**RE: 3308 4th Street Apartment Building
Revised Grading and Drainage Plan
Engineer's Stamp Date: 10/22/18
Hydrology File: H14D109**

3308 4th SREET NW
GRADING AND DRAINAGE PLAN

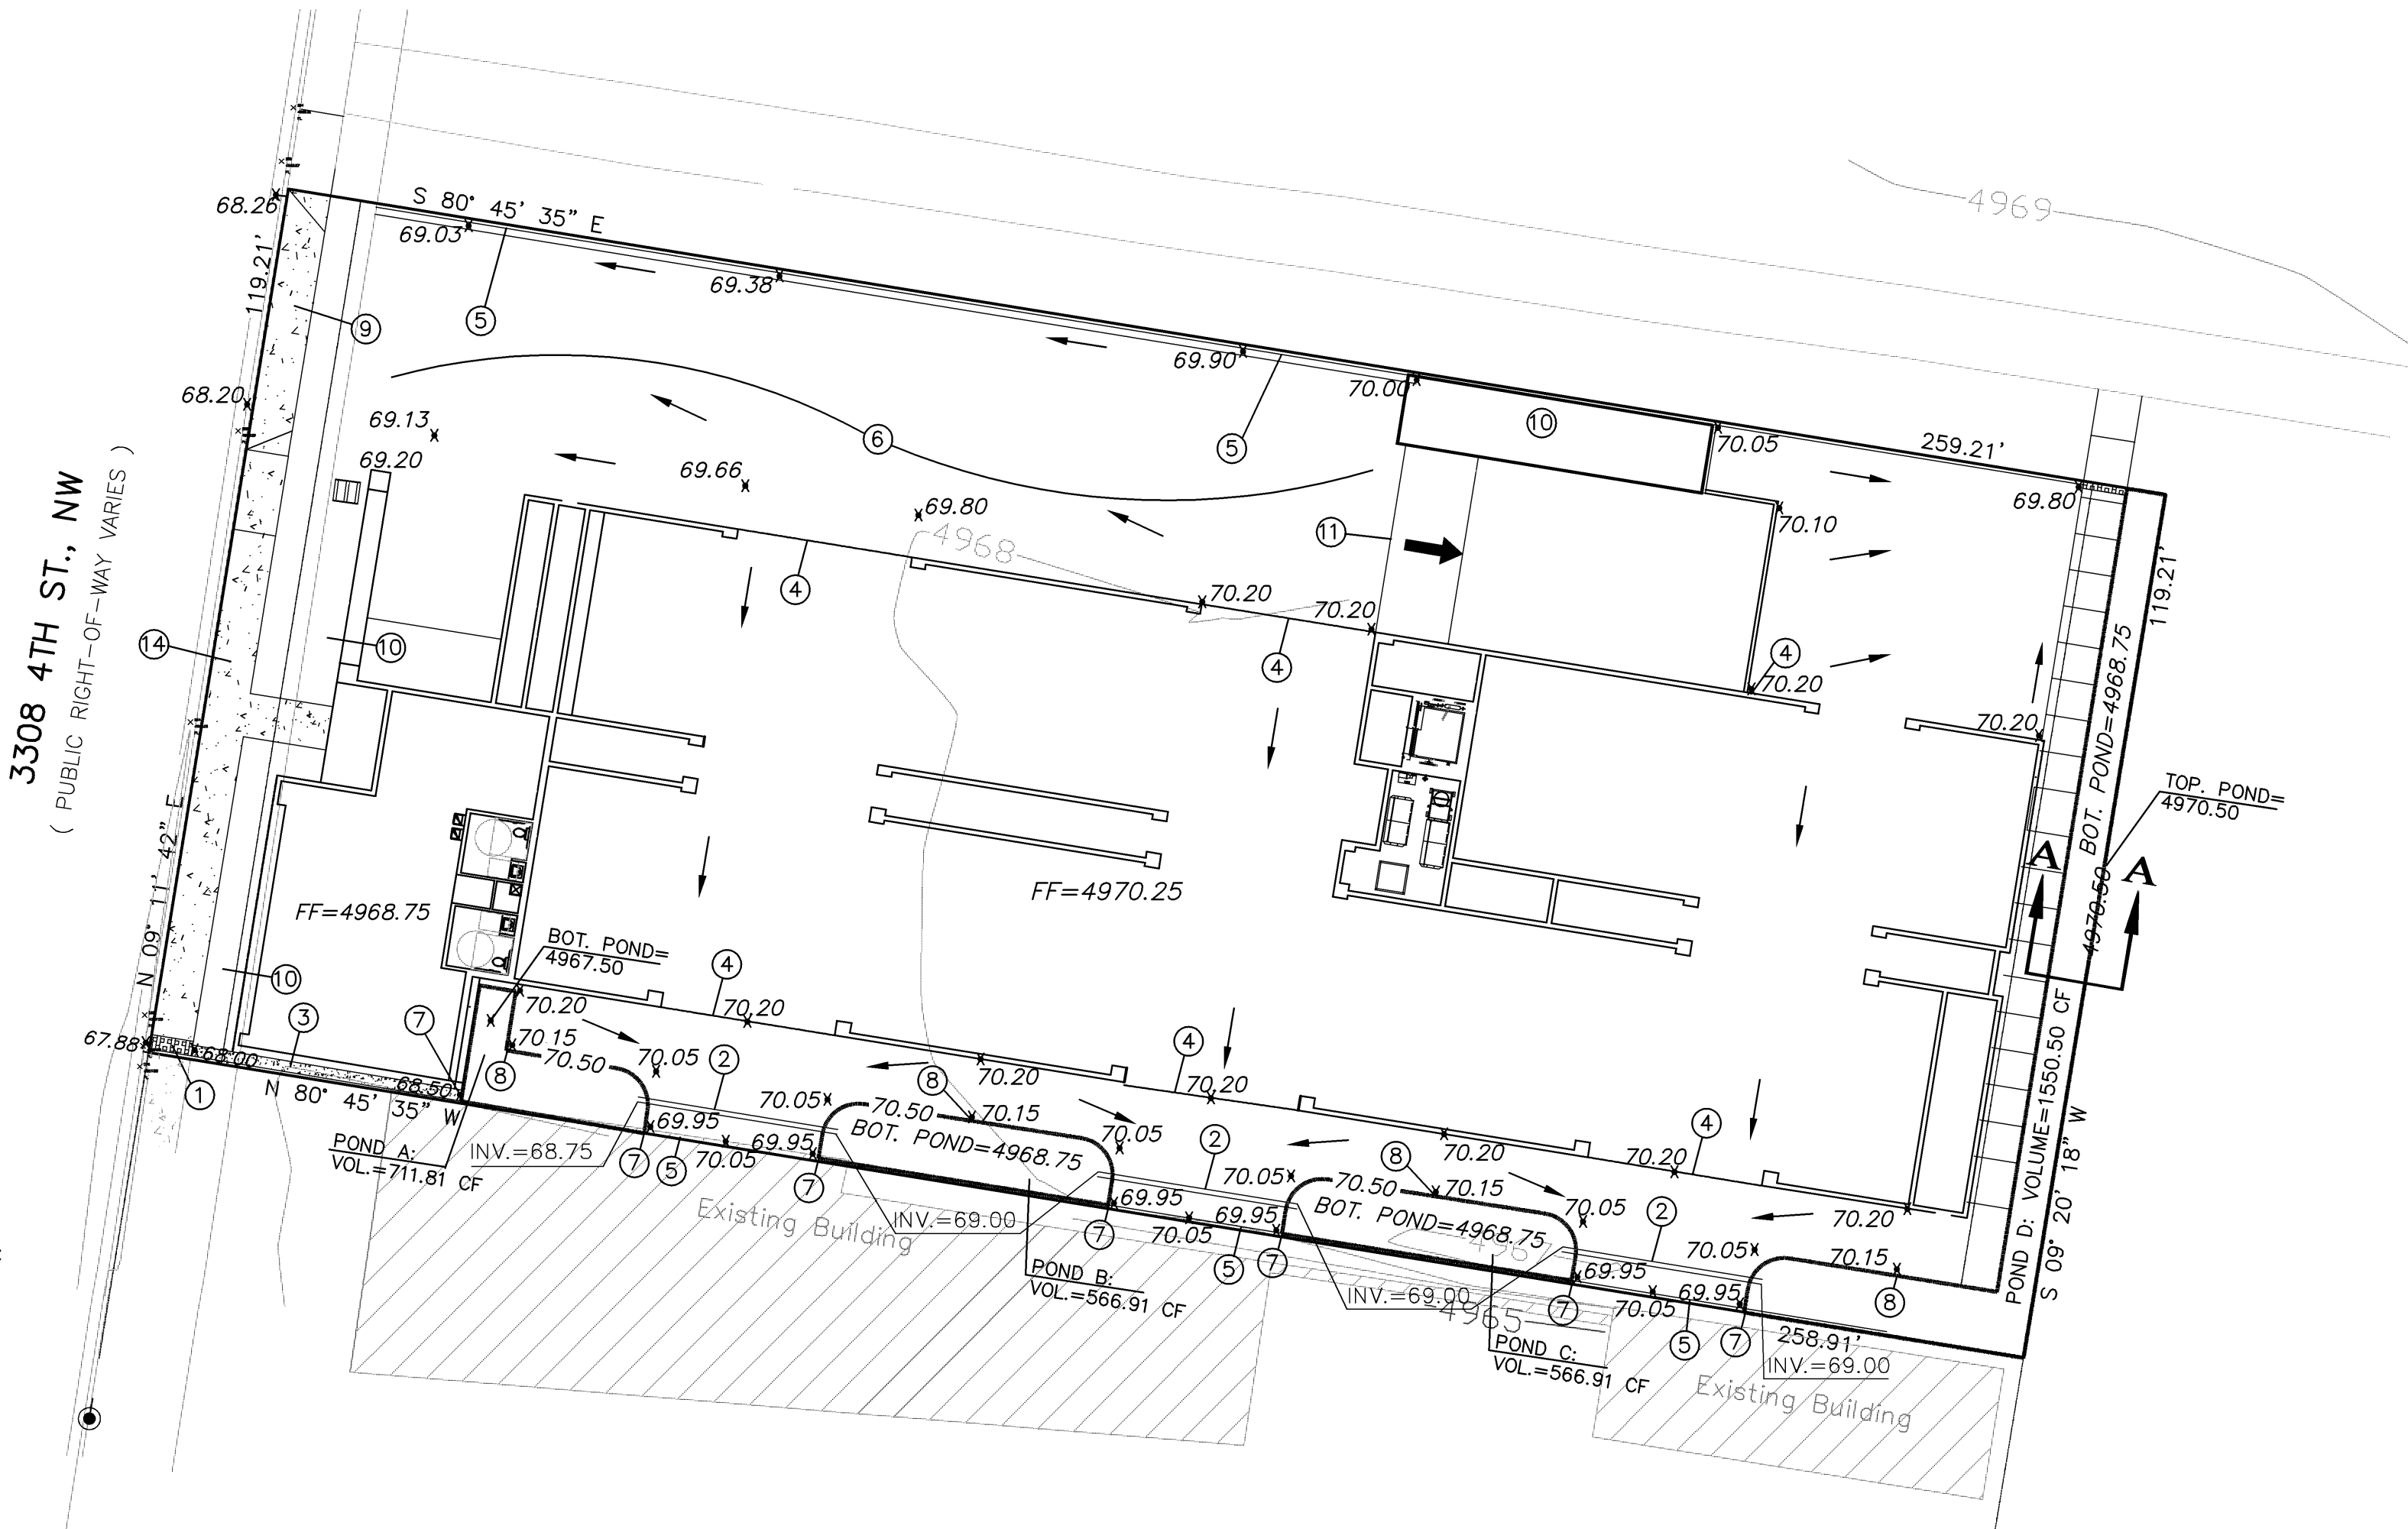
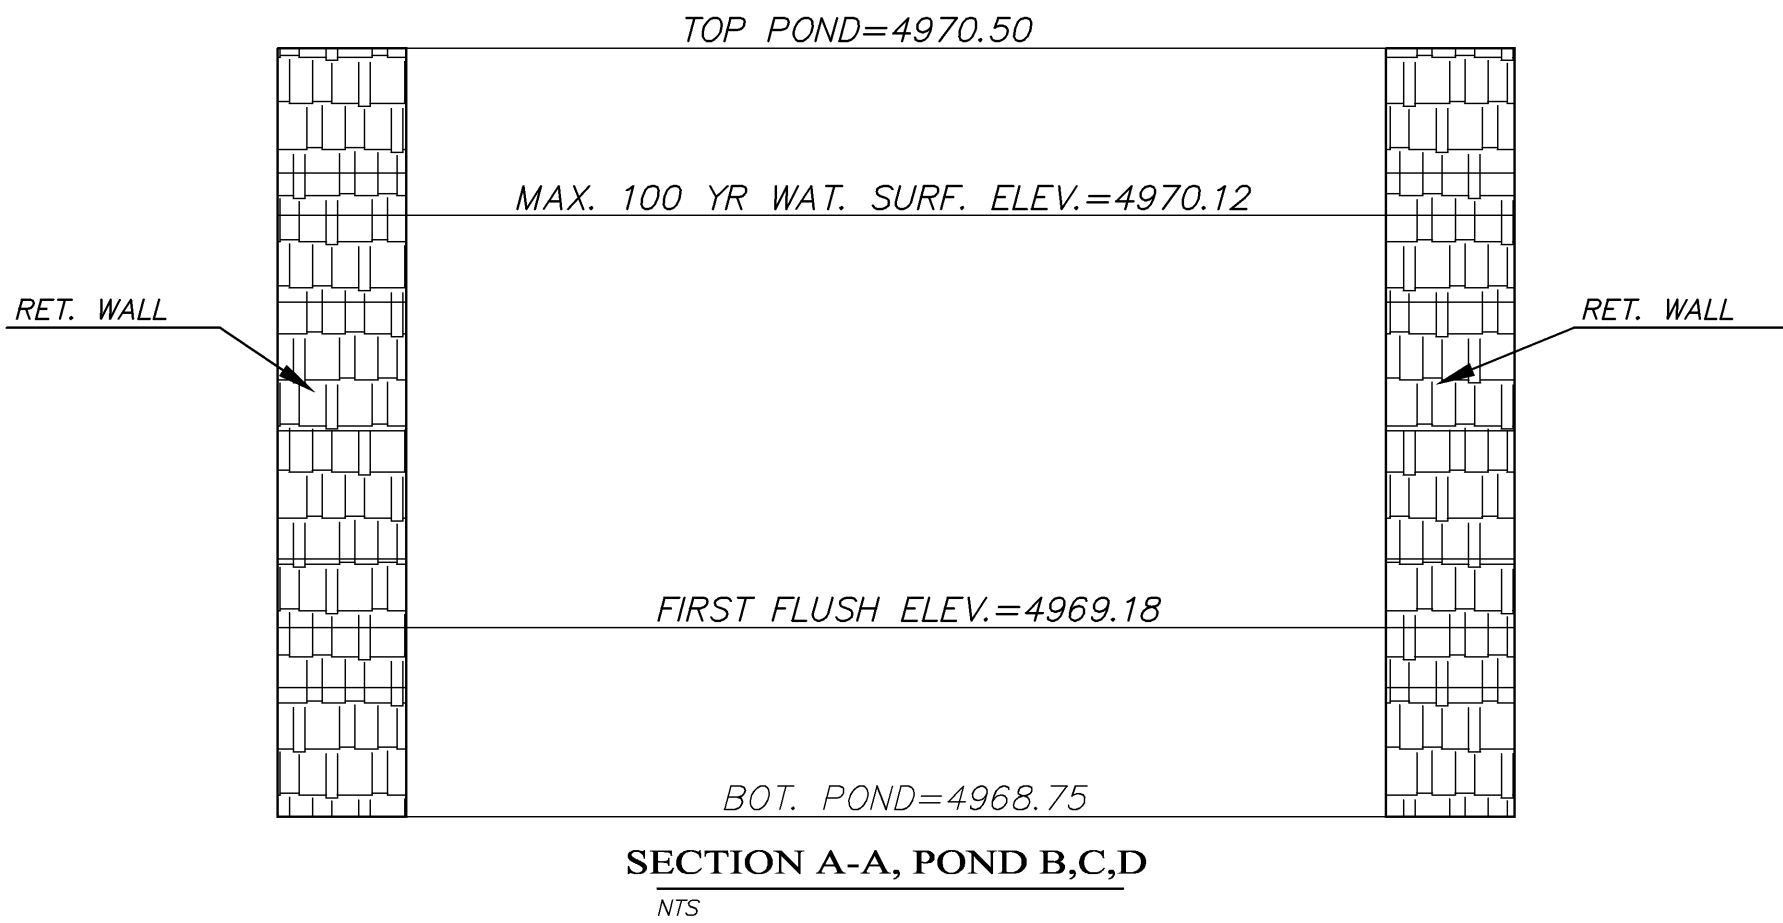
Based upon the information provided in your revised submittal received 10/24/2018, the Grading and Drainage Plan is approved for Building Permit, Grading Permit and SO-19 Permit.

Please provide Private Facility Drainage Covenant per Chapter 17 of the DPM prior to Permanent Release of Occupancy for the first flush ponds. Please submit these to the 4th floor of Plaza de Sol. A \$25 fee for each will be required.
